**CITY OF PORTLAND, MAINE
DEVELOPMENT REVIEW APPLICATION
PLANNING DEPARTMENT PROCESSING FORM
Planning Copy**

International Car Parts of NH
Project Name/Description

Subject: Application #200-004; CBL330H003001
176 Riverside Industrial Parkway
Portland, Maine
Response to Staff Comments

**RE: Site Plan Review: 176 Riverside Industrial Parkway
6,090 square-foot Building
Application # 200-0004; CBL 330 H003001**

ADJUSTABLE CUTOFF WALL PACK (WP-A)

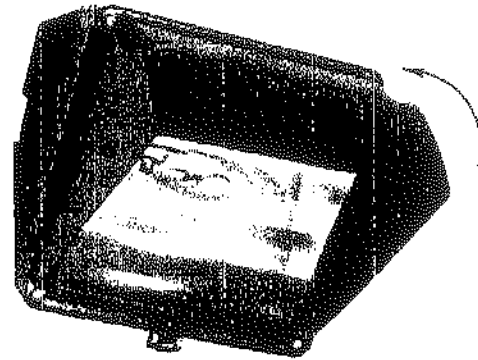
All fixtures, including wall packs, shall be a "cut-off" type *where lenses, refractors or lamp sources do not extend below the surface of the fixture housing and no direct light shall be directed at the above the horizontal plane.*

Phil, this is the fixture that we are proposing to use for the outside wall packs. This fixture has an adjustable cutoff glare shield, to deflect the light. My electrical sub-contractor is planning to install these fixtures by the end of the week. Any questions please call. Thanks Rick

BOYLE BUILDING CORP.
PROPOSED BUILDING
176 RIVERSIDE INDUSTRIAL PARKWAY
PORTLAND, MAINE

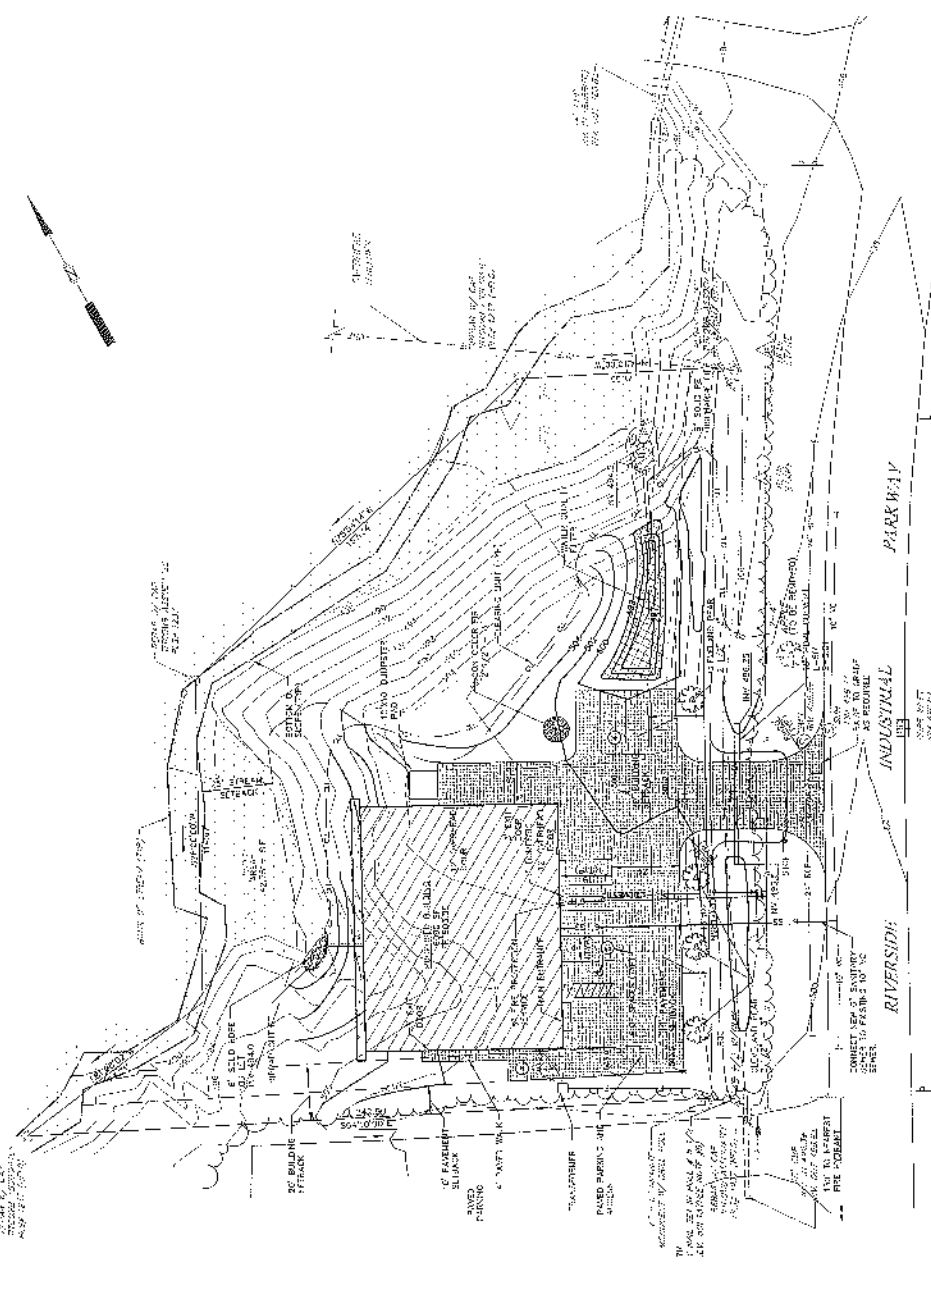
- 1. The location of existing underground telephone and gas lines and connections to these lines for the proposed building have not been indicated on the site plan.**

- 2. A curbing detail has not been included on the project detail sheets.**

- 3. A pavement repair detail for Riverside Industrial Parkway has been included; however, the location of necessary repairs has not been shown on the site plan.**

4. **The included pavement detail for the parking lots and entrances differs from the typical pavement sections given in the City of Portland Technical and Design Standards and Guidelines.**

5. **The City of Portland Technical and Design Standards and Guidelines require 12" of crushed stone over a pipe in their typical pipe trench detail. Only 6" of crushed stone are indicated in the site plan.**

6. **A detail for a precast concrete manhole is included on the detail sheets; however, the installation of a new manhole is not indicated on the plans. If a manhole will be installed, this needs to be indicated on the site plan, and additional details need to be included for the manhole frame and cover.**

SME's Response. The underground telephone service will run in the same trench as the electrical and run to Pole #5-1/2. Telephone service along Riverside Industrial Parkway is overhead. A gas service has been added to the site plan, along with the 6-inch gas main in Riverside Industrial Parkway.

SME's Response. Curbing details have been added to the Detail Sheet.

SME's Response. The detail for repairs to Riverside Industrial Parkway is provided for any repairs required due to utility installation. The repairs will be located where utility connections extend into existing pavement.

SME's Response. The parking lots and entrances detail has been revised to match the City's pavement requirement. However, more gravel will be provided than required.

SME's Response. The typical pipe trench detail has been revised to reflect 12 inches of crushed stone cover over the pipe.

SME's Response. The manhole detail has been removed. A manhole is not required.
